# TECHNICAL INFORMATION

63951

- Subject** ▶ Change of Pan Head Screws for fastening Bracket
- For Models** ▶ 1902
- Country** ▶ All countries
- Description** ▶ The length of Pan Head Screws for fastening Bracket has been changed from 20 mm (13/16") to 25 mm (1").

| ▶ Current   | ▶ New  |

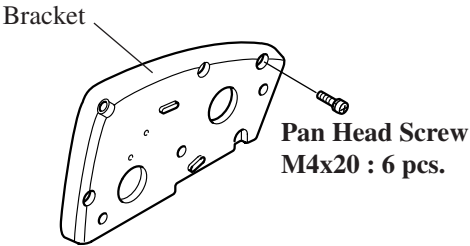
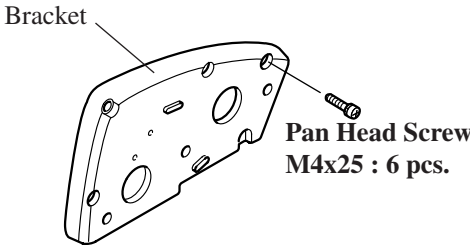
| ▶ Current   | ▶ New  |
|---|--|
|  <p>Bracket</p> <p>Pan Head Screw<br/>M4x20 : 6 pcs.</p> |  <p>Bracket</p> <p>Pan Head Screw<br/>M4x25 : 6 pcs.</p> |

| Item No. | Current part                     |  | Q'ty | I/C | New part                         |  | Q'ty | Note |
|----------|----------------------------------|--|------|-----|----------------------------------|--|------|------|
| 035      | Pan Head Screw M4x20<br>911138-5 |  | 6    | ←   | Pan Head Screw M4x25<br>911148-2 |  | 6    |      |

The arrow ← means that the new part can be substituted for the current.

From serial No.172392E (May, 2001)
